Westinghouse
Electric Corporation

SUBJECT: WESTINGHOUSE RESPONSES TO NRC REQUESTS FOR ADDITIONAL
INFORMATION ON THE AP600

Question 440.306

Figure 440.432-1 Comparison of the Pressure Upstream and Downstream of the ADS Package Between Choked and Unchoked Cases

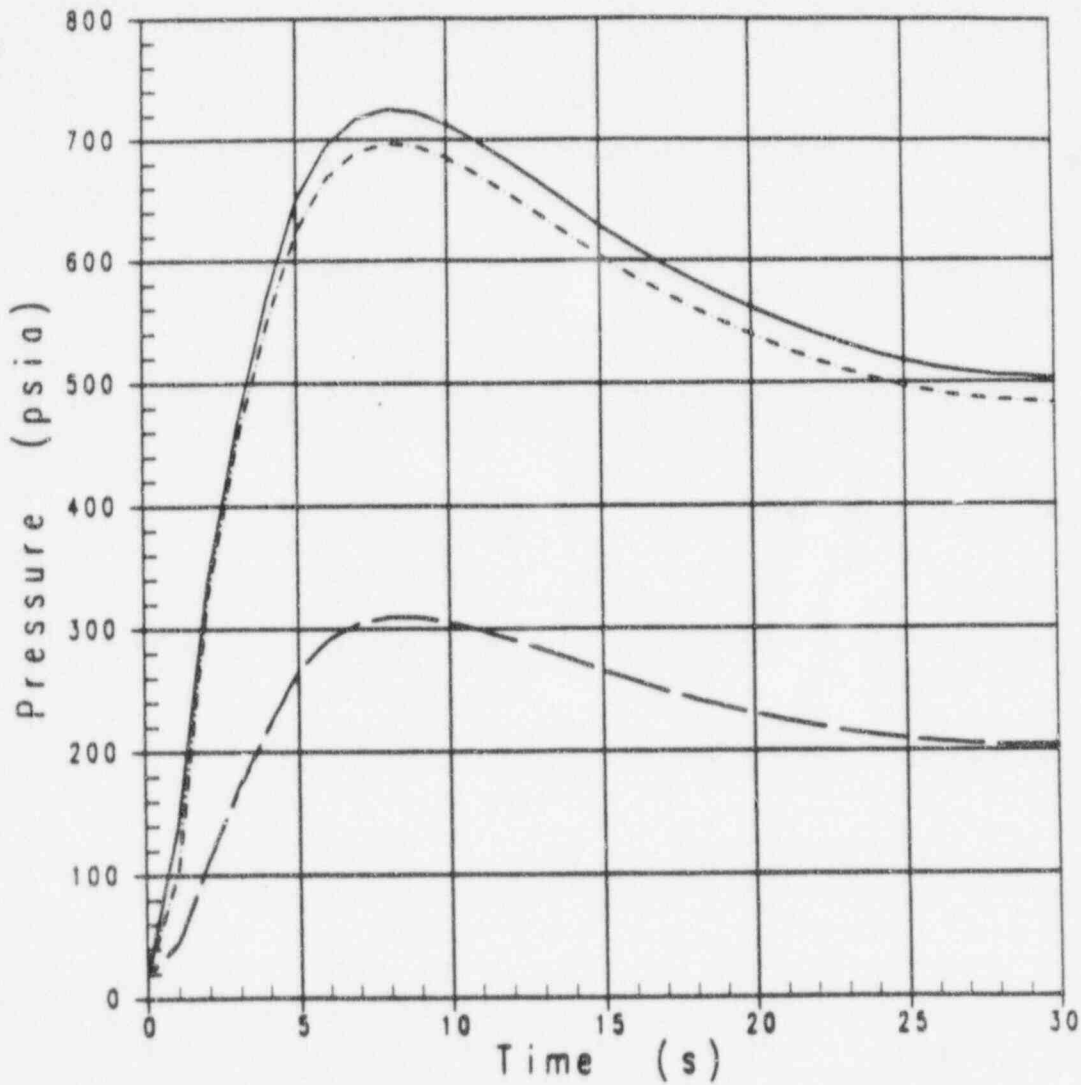
On page 3-1, it is stated that the entire ADS package is modeled as a single flow link and that the effective loss coefficient of the ADS system is also not needed since the flow is choked for all tests. This appears to be an over simplification since the three ADS valves in Fig. 3-1 do not appear to be arranged symmetrically. As such, choking is not expected to occur simultaneously in these lines. Please identify where choking occurs in the tests and show that the omission of form losses in the momentum equation do not influence the system depressurization rate. That is, please explain why asymmetric effects can be ignored in the modeling of the ADS lines. Please also show how the inertia and line loss terms were computed for the single flow link simulating the three ADS valves depicted in Fig. 3-1. Also, discuss the modeling of momentum flux effects in the momentum formulation in the ADS lines using NOTRUMP since there are many contractions and expansions in these lines.

In the NOTRUMP ADS preliminary validation report, the ADS valve package was considered to be choked. However, after the NOTRUMP ADS preliminary validation report was issued, an approach to verify ADS choking was developed (Appendix D of Reference 440.432-1) which indicates that the flow at the ADS package is not choked for most of the tests as discussed below.

When valve VLI-2 is choked, the flow rate will be the same whether the ADS valve package is choked or not, because the upstream central valve, VLI-2, is the limiting choke location, which determines the flow rate. Since the depressurization rate of the steam/water supply tank (pressurizer) depends only on the flow rate (see the response to the RAI question 440.437), the depressurization rate will also be the same whether the ADS valve package is choked or not. To show this, Test 320 with all three ADS stages open was rerun with the NOTRUMP code by considering the ADS valve package not choked. As expected, the flow rate was the same as the case with the ADS valve package choked which is in the report. The pressure is also the same at all locations except at the upstream of the ADS package as shown in Figure 440.432-1. Therefore, it can be inferred that if all ADS lines are not choked simultaneously, the flow rate and depressurization will still be the same.

In the calculations for Figure 440.432-1, the loss coefficient of the ADS package as a single link is computed as follows:
